SB-GA8-2018-182

Service Bulletin

Replacement of AK950 Avionics Cooling Fan with a Lonestar CRB-6457

Figure 1 – Non dimensioned location of replacement fan

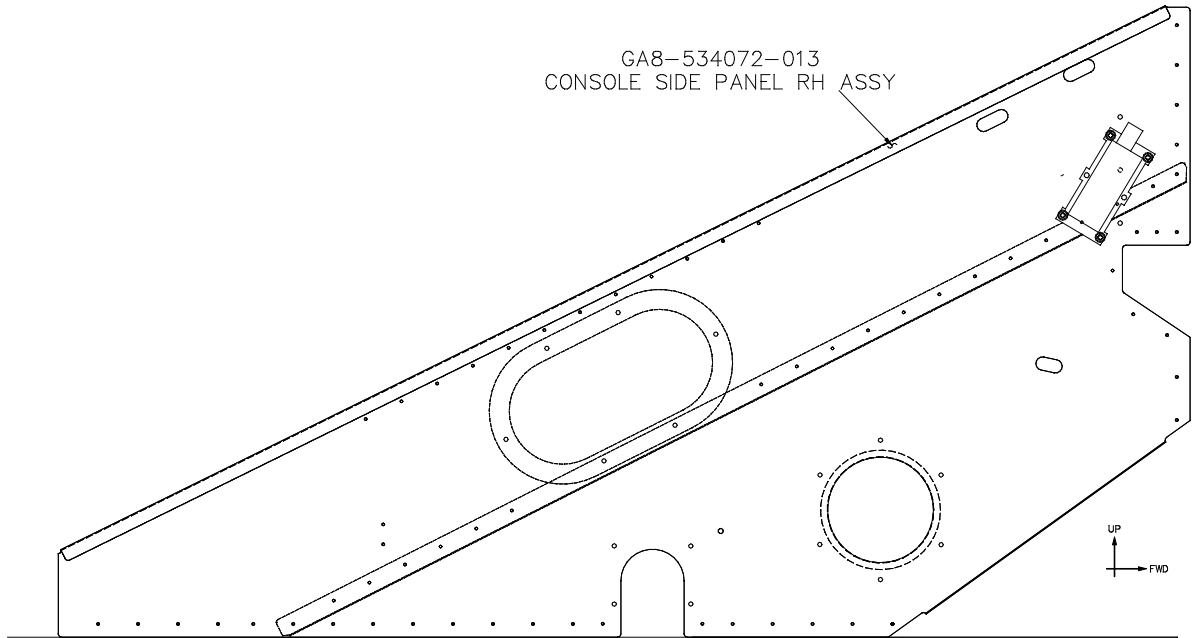
- 1.1. Disconnect the electrical plug connected to the fan.
- 1.2. Remove the installed Ameri-King avionics cooling fan.
- 1.3. Install the LoneStar fan in accordance with Figure 1, Figure 2 & Figure 3. Take great care when locating the fan to the structure to avoid drilling through the stringer shown in Figure 2.

Figure 4 – Modification to electrical overhead panel

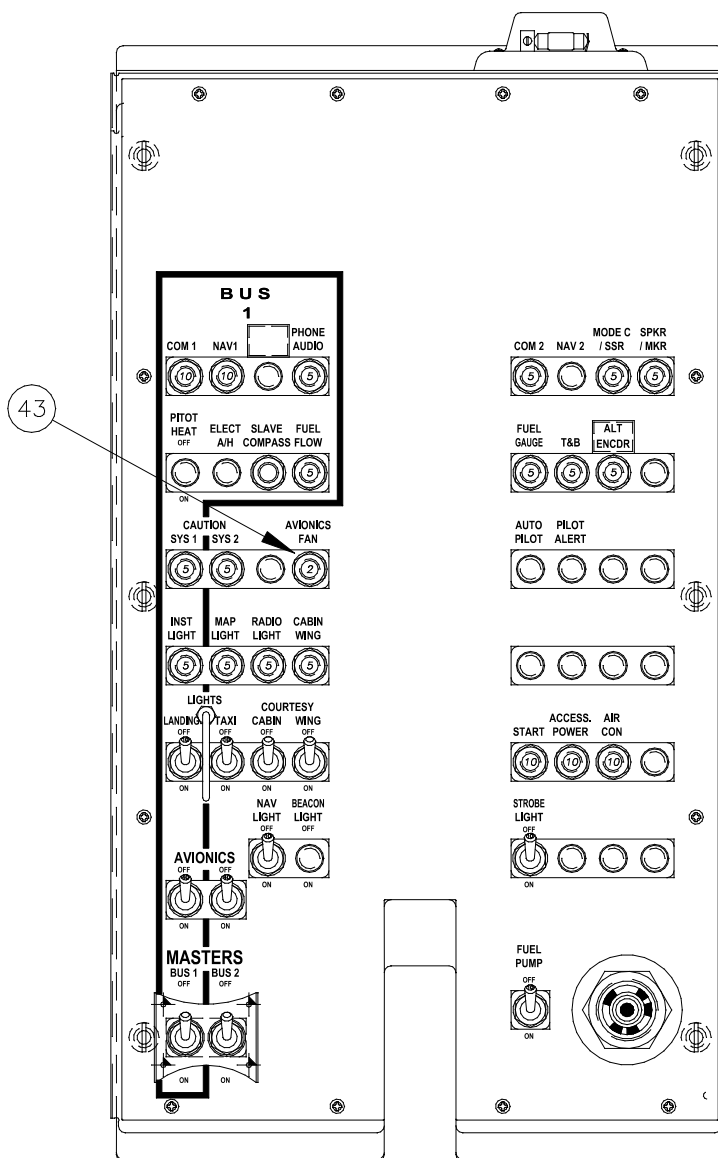
- 2.1. Lower the electrical overhead panel. Refer to the GA8/GA8-TC 320 Service Manual Section 31-10.
- 2.2. Remove the existing 5A circuit breaker and replace with item 43 as noted in Figure 4.
- 2.3. Cut off the electrical connector used to plug into the Ameri-King fan.
- 2.4. Re-terminate the wires in accordance with Figure 5. Refer to TE Connectivity Instruction Sheet 408-7300 Rev E or later for wire preparation for guidance.
- 2.5. Mark the connector housings using a label or indelible black ink accordance with Figure 5.
- 2.6. Join the cap and plug housings.
- 2.7. Secure all loose wires associated with this installation onto the adjoining cable harness.
